| <b>PROJECT NAME:</b> | Rangeley Main Street Sidewalk Project |
| <b>SUBJECT:</b>      | <b>Addendum 1</b>                     |

**MAIN STREET /US ROUTE 4 SIDEWALK IMPROVEMENTS**

**April 7, 2016**

|   |  | <b>ADDENDUM NO. 1</b><br>REFERENCE: DWG C-6 |                           |          | FIGURE: |

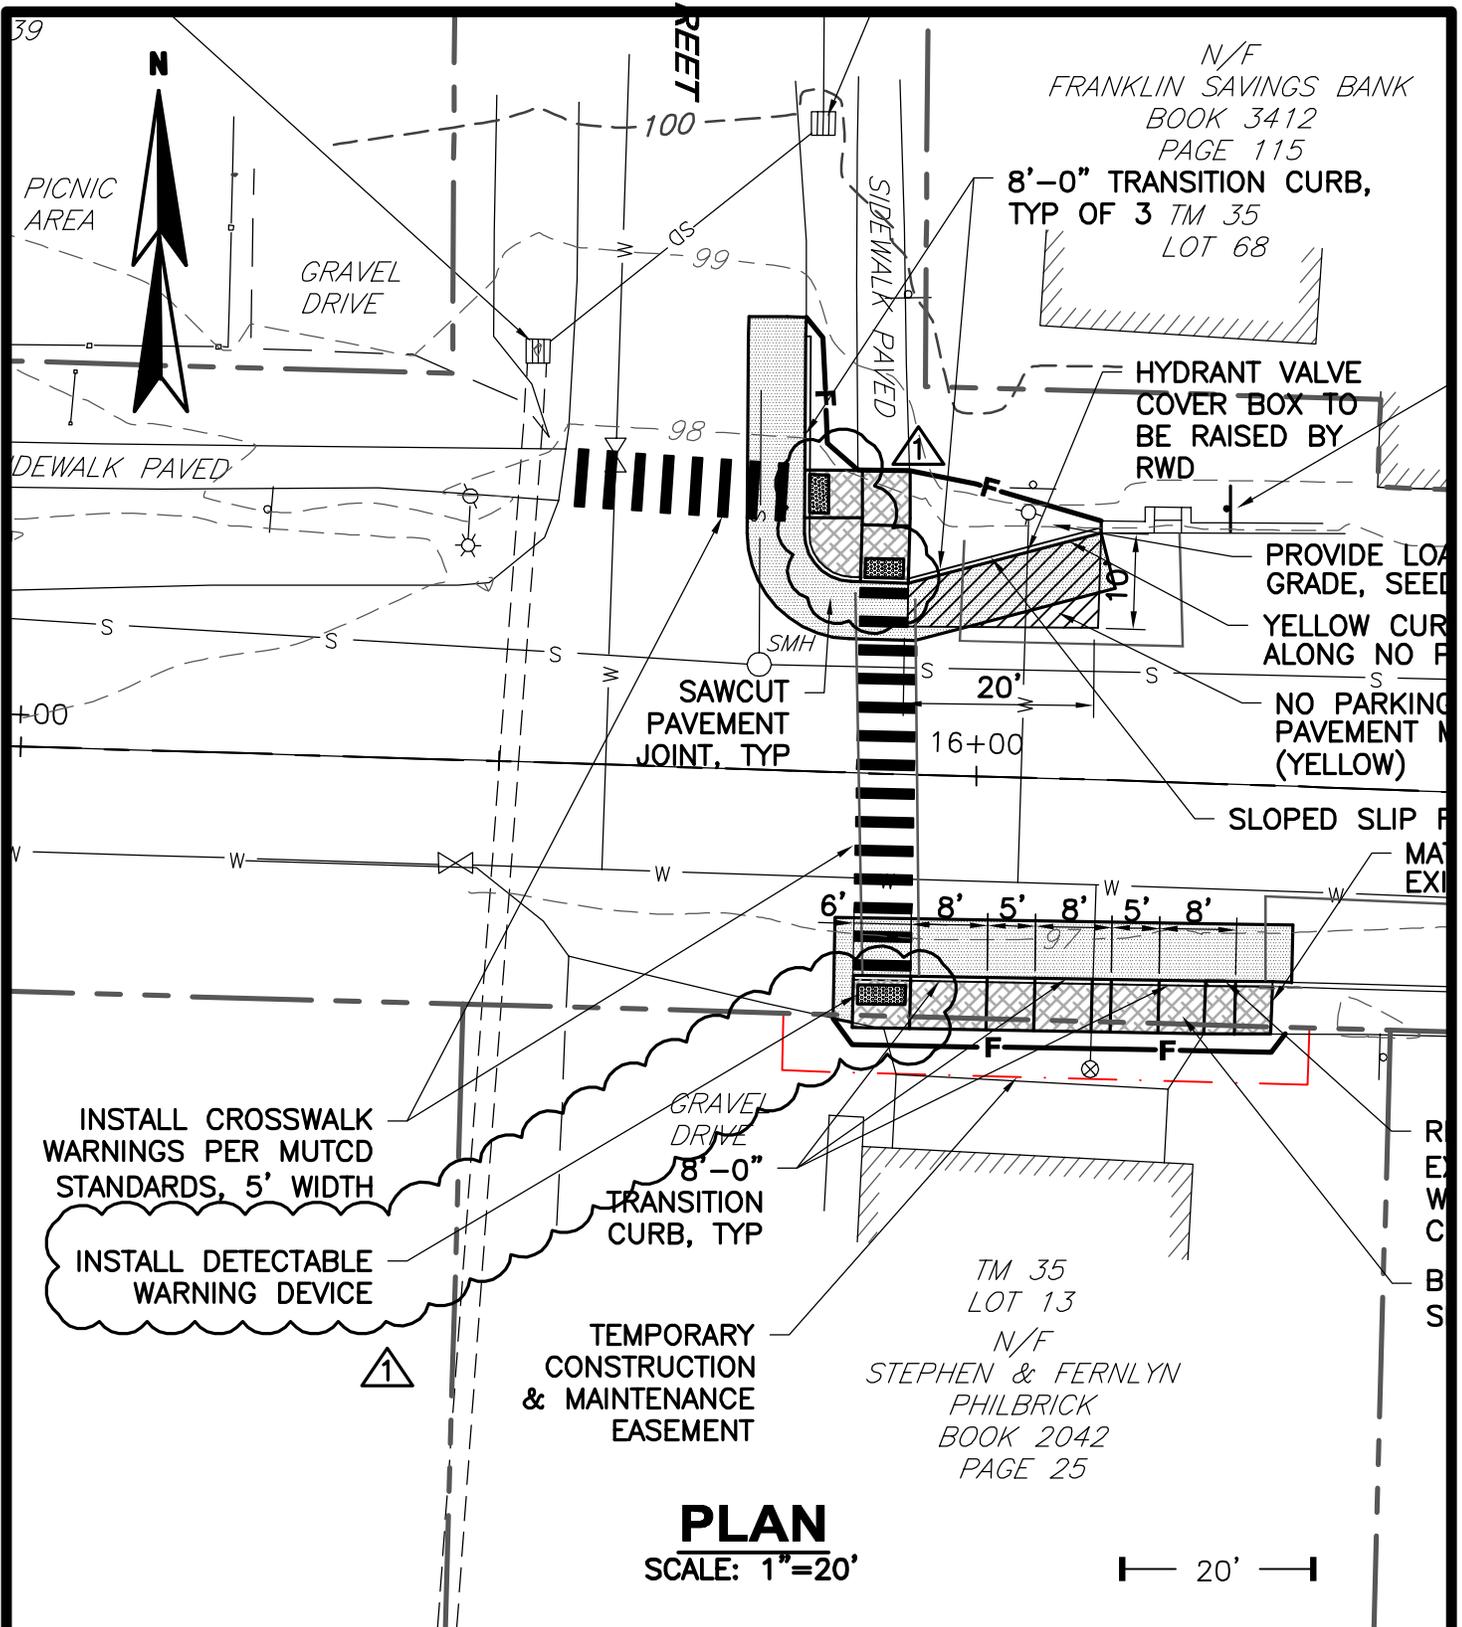
1. Drawing C-5 – **REPLACE** all of the references to “Type R3165” catch basin frame and grate with “Type R3303”.
2. Drawing C-5 – detectable warning fields shall be placed at the Allen Street intersection per the sketch attached to this addendum.
3. Drawing C-5 – Inverts and pipe slopes for the drainage system are revised as noted below. A Conformed Drawing will be issued to the Contractor after contract award.
  - a. Invert out at CB-1 = 93.25
  - b. 18” pipe slope from CB-1 to CB-2:  $S=0.0144$
  - c. Invert In at CB-2 = 89.95
  - d. 15” Invert In at CB-2 = 90.2
  - e. Invert Out at CB-2 = 89.85
  - f. 18” pipe slope from CB-2 to CB-3:  $S=0.0025$
  - g. Invert In at CB-3 = 89.58
  - h. Invert out at CB-3 = 89.48

4. For Item No. 608.26, Curb Ramp Detectable Warning Field. Because the locations are not shown on the Plans as stated in Special Provision 608, can you provide a Standard Detail showing the location of the warning plates in the 8' long by 5' wide sidewalk and curb transition areas.

|   |  | ①   | DETECTABLE WARNING DEVICE | MRL      | JDP     |

**SLOPED CURB ON BINDER DETAIL**  
NTS

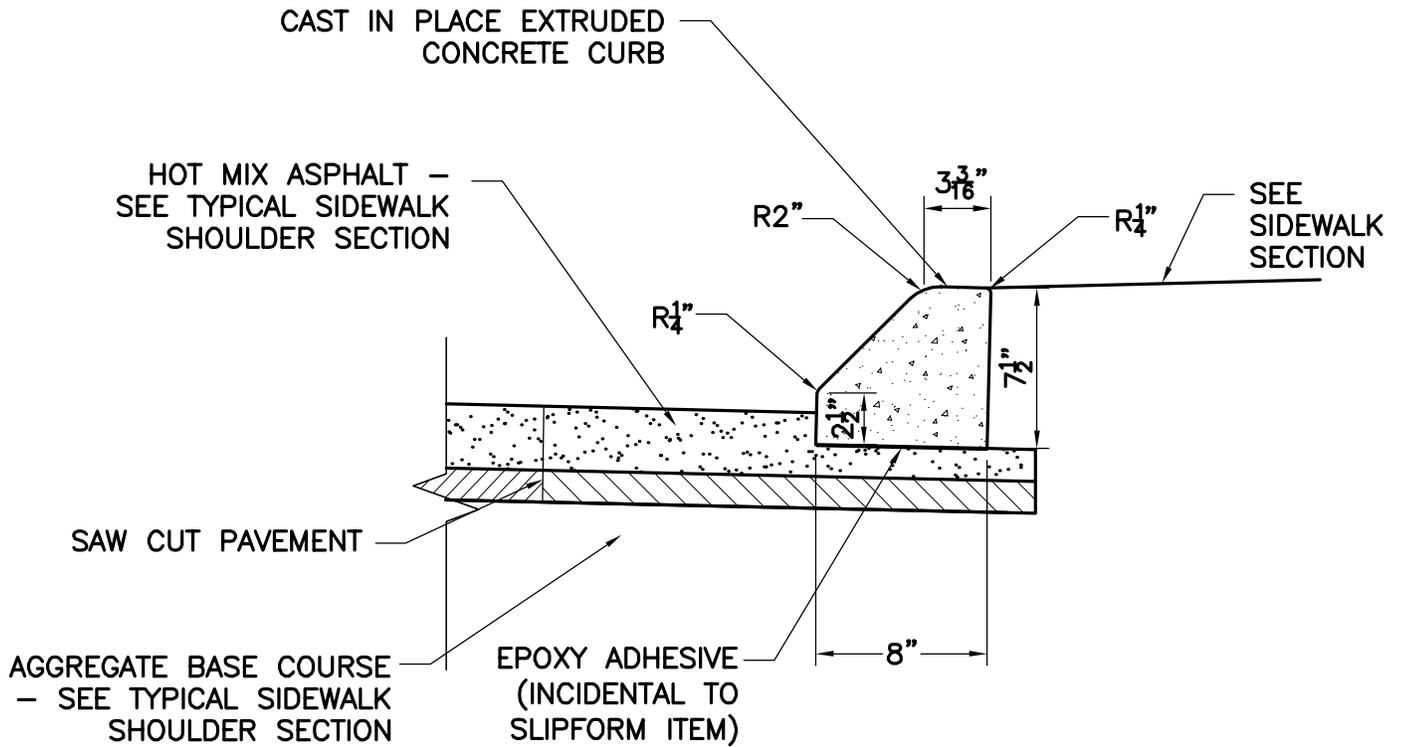
- i. 18" pipe slope from CB-3 to outlet:  $S=0.0025$
  - j. Invert out of 18" drainage system = 89.20
4. Drawing C-9 and C-10 – standard slip form curb molds shall be utilized for this project. For vertical curb sections, the mold shall have an 8" base and a top width of 6".
  5. Drawing C-9 and C-10 - Slip form sections shall be per the detail attached to this addendum.

3. On Drawing C-6, there is a note calling for "sloped" slipform curb at Sta. 16±00 Lt. but the cross section for Sta. 16±00 Lt. is showing a vertical curb form. Which one is correct? If "sloped" is correct, there are no details for it in the Contract Documents & Plans. And you will need to provide them.

|  | ①  | SLOPED CURB ON BINDER DETAIL | MRL      | JDP                 |

**Structure:** CB#1  
**Job Number:** 2016-04-07 10:43:16  
**Job Name:** Main St Sidewalks  
**Job Location:** Rangeley, ME  
**Contractor:** M & H Logging & Excavation  
**Frame/Ring:**  
**Channel:** No Channel  
**Coating:**  
**Boots:** Yes (1)  
**Steps:**  
**AFSF:** 1.11

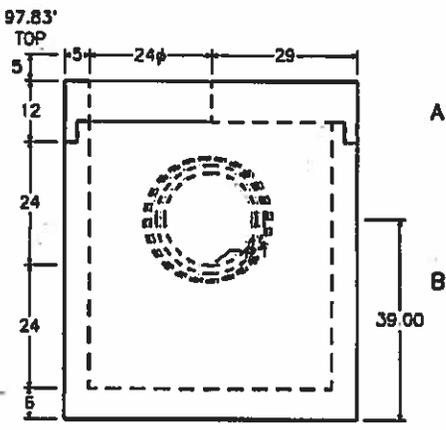
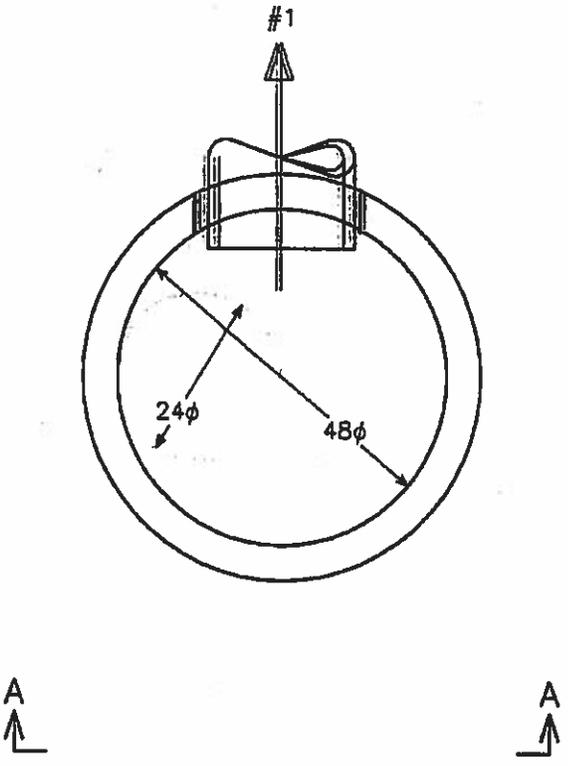
"Attached are my CB details. There is no way we can use  
cone sections. Even with slab tops they are tight and won't fit  
the frames. As you can see CB#2 only has 3" for the frame and  
grate and CB#1 and #3 only has 5". "

→ Attached are my CB details. There is no way we can use cone sections. Even with slab tops they are tight and won't fit the frames. As you can see CB#2 only has 3" for the frame & grate and CB#1 & #3 only has 5".
